RAI 343
03.07.02-72

Enclosure 2
UN#13-056 1.142 (NRC, 2001)).
Page 59 of 105

**Table of Changes to CCNPP Unit 3 COLA
Associated with the Response to
RAI 315, Question 03.07.02-64 (Part C),
Calvert Cliffs Nuclear Power Plant, Unit 3**

Figure 3E-2— {Reinforcement for Forebay and UHS Makeup Water Intake Structure Basemat}

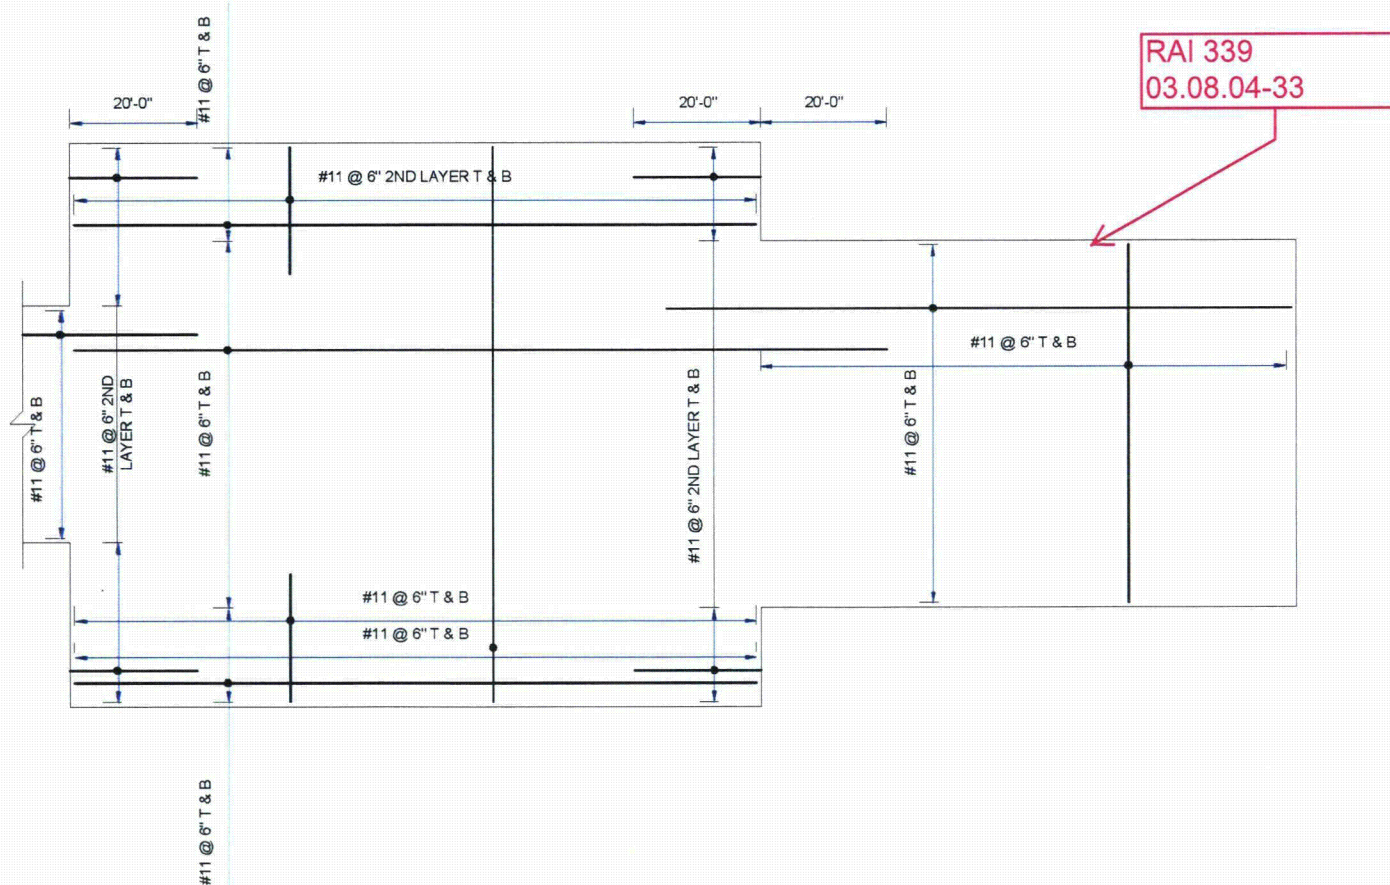
RAI 339
03.08.04-33
